Project	IEEE 802.16 Broadband Wireless Access Working Group < http://ieee802.org/16 >	
Title	Proposed Modification on Protocol Functionalities for Supporting IEEE 802.16m E-MBS	
Date Submitted	2008-1-21	
Source(s)	Chun-Yen Wang, ITRI Richard Li, ITRI Chun-Yuan Chiu, ITRI Chie-Ming Chou, ITRI Fang-Ching (Frank) Ren, ITRI Wern-Ho sheen, NCTU/ITRI Yuefeng Zhou, NEC Weili Ren, NEC	Voice: E-mail: ChunYen@itri.org.tw richard929@itri.org.tw Yuefeng.zhou@ieee.org
Re:	IEEE 802.16m-07/047 - Call for Contributions on Project 802.16m System Description Document (SDD), shoot for "Proposed IEEE 802.16m Protocol Architecture and main functionalities per protocol layer" topic.	
Abstract	This contribution proposes some modifications on protocol functionalities from supporting E-MBS point of view.	
Purpose	For discussion and approval by TGm	
Notice	<i>This document does not represent the agreed views of the IEEE 802.16 Working Group or any of its subgroups. It represents only the views of the participants listed in the "Source(s)" field above. It is offered as a basis for discussion. It is not binding on the contributor(s), who reserve(s) the right to add, amend or withdraw material contained herein

Fig. 1. IEEE 802.16 Protocol Layer

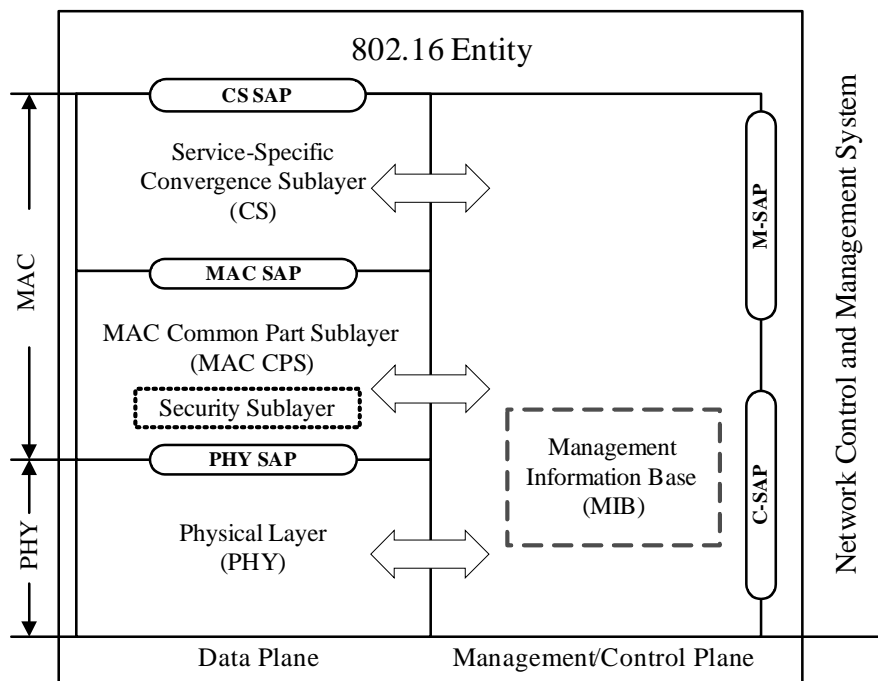
The proposed IEEE 802.16m protocol architecture is similar to that of the existing 802.16 system as shown in Fig. 1 with some modifications as described in the following.

In IEEE 802.16 protocol structure, the Service-Specific Convergence Sublayer is responsible for service classification and payload header compression (PHS). However, we suggest that PHS (if required) shall be done in the ASN gateway when transmitting E-MBS services. On one hand, we can save many efforts to maintain the header compression context synchronized between multiple BSs to achieve macro diversity transmission; on the other hand, if the PHS is performed in ASN gateway, there is only one compressor context per E-MBS service, so MS's decompressor context can keep the same when moving into a new cell. Therefore, performing PHS in ASN gateway for E-MBS transmission can save handover interruption time and reduce extra implementation complexity.

Proposal 1: The Service-Specific Convergence Sublayer performs payload header compression (PHS) (if required) except for E-MBS transmission.

Most functionality of the MAC Common Part Sublayer (MAC CPS) and Physical layer in single-BS access are kept the same as that for unicast transmission so as to maintain the maximum commonality between E-MBS and unicast transmission. But for MBSFN transmission mode, multiple BSs are mandatory to transmit the same signal at the same time/frequency resource. Therefore, some management operations, such as data scheduling and resource allocation in the MAC CPS layer, and adaptive modulation and coding (AMC) schemes in the PHY layer, shall be controlled by a centralized coordination entity (i.e., MBS server).

Proposal 2: The MAC Common Part Sublayer shall perform data scheduling and resource allocation except for MBSFN transmission.

Proposal 3: The PHY shall adaptively select a suitable radio configuration (e.g., modulation and code rate) except for MBSFN transmission.

The service-specific CS performs payload header compression (PHS) (if required) except for E-MBS transmission.

The MAC CPS shall perform data scheduling and resource allocation except for MBSFN transmission.

The PHY shall adaptively select a suitable radio configuration (e.g., modulation and code rate) except for the MBSFN transmission.
